EVALUATION OF THE WIPP PROJECT'S COMPLIANCE
WITH THE EPA RADIATION PROTECTION STANDARDS
FOR DISPOSAL OF TRANSURANIC WASTE

Environmental Evaluation Group
7007 Wyoming Blvd., NE, Suite F-2
Albuquerque, New Mexico 87109

March 1998

Fig. 20. Solution Mining of Brine and Natural Gas Storage Wells.

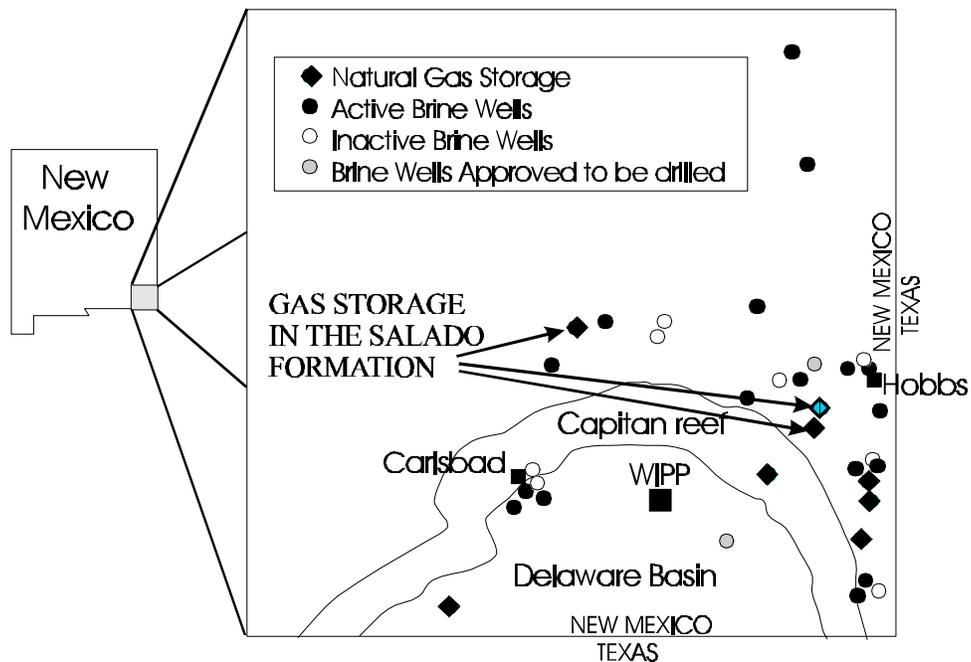
As shown in Figure 20, there are three solution mining operations for brine production near the city of Carlsbad area and at least 16 miles from the WIPP site. EPA mentions only one about 14 miles from the WIPP Site. Furthermore, EPA does not discuss the trend towards drilling brine production facilities closer to WIPP. Brine well BW-26 has been approved for production from the Salado Formation. The solution mining operation would be located between Jal and Carlsbad to meet the demand for drilling brine. The well was approved to remove salt from the Salado formation which lies between 1500 to 2300 feet deep. The subsidence calculations provided by DOE were for a facility that is 583 feet deep.

Fig. 21. Permeability vs. Porosity Model With BRAGFLO for Left) Marker Bed 139 and Right) Marker Beds a and b.

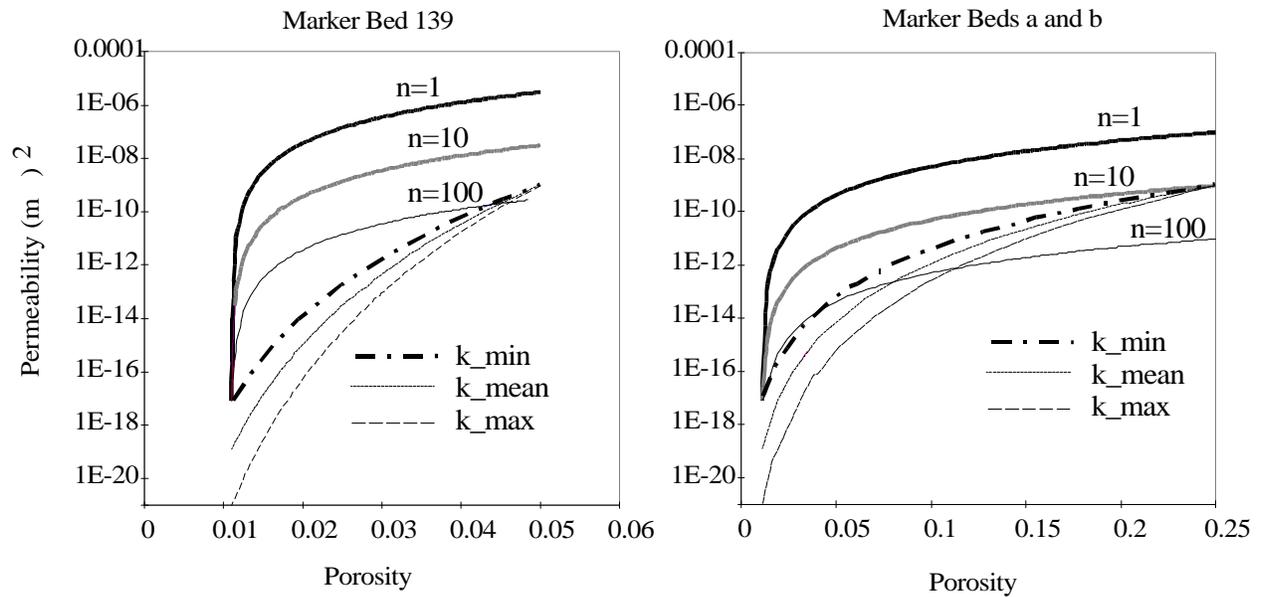
Our conclusion is that the conceptual model BRAGFLO for anhydrite fracturing may be a valid description for pore pressures less than 1 MPa below lithostatic but a cubic law formulation of the permeability-porosity relationship is valid above this threshold. As demonstrated by Freeze et al. (1995), the BRAGFLO parameters can not be set to reasonably represent this region. Figure 21 is an updated version of Figure 2 of Freeze et al. (1995). The BRAGFLO model is based on CCA parameters for marker bed 139 and anhydrite layers A and B respectively. The figure shows the permeability-porosity relationship of the BRAGFLO model to a cubic law based model for multiple fractures. Our concern is that the BRAGFLO model under-represents permeability by more than four orders of magnitude for small porosity increases. By setting the model parameters to match a cubic law fracture model at large porosity, a large error may have been introduced for small porosity changes.

The BRAGFLO model has not been tested against either laboratory or hydrofracing experiments or other standard fracture modeling codes. This comparison should be made before the model can be accepted as valid.

Fig. 24. Fractional Discharge Of Uranium Across The LWB Within 100,000 Years, With Blowout Section Of 10,000 Years. Reproduced from Rucker (1998).

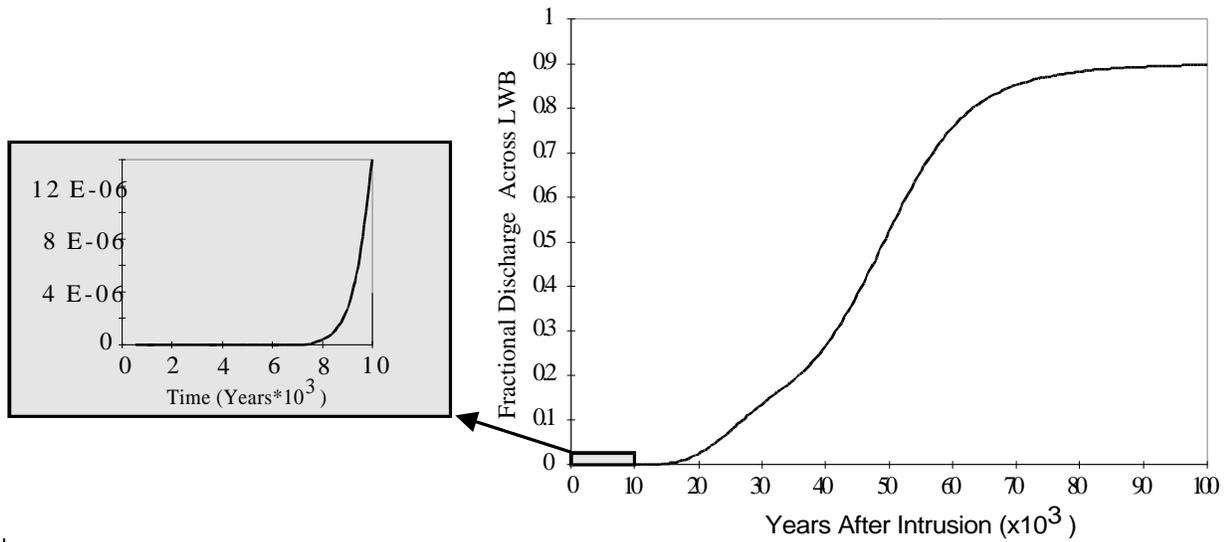
During discussions with our consultants after the July 30 meeting, it was pointed out that if the calculations for release were continued beyond the 10,000 year period, release to the accessible environment will be seen. Rucker (1998) also shows that a significant fraction of actinide mass will cross the LWB beyond the 10,000 regulatory time frame. Figure 24 (reproduced from Rucker, 1998) shows the fractional discharge of Uranium with a retardation coefficient of 2.0

crossing the LWB. The figure demonstrates that very little mass that enters the Culebra crosses the LWB during the initial 10,000 years and almost the entire nuclide mass fraction will cross the LWB by 70,000 years post intrusion. The EEG recommends that the performance assessment calculations be extended beyond 10,000 years to determine long-term system performance.
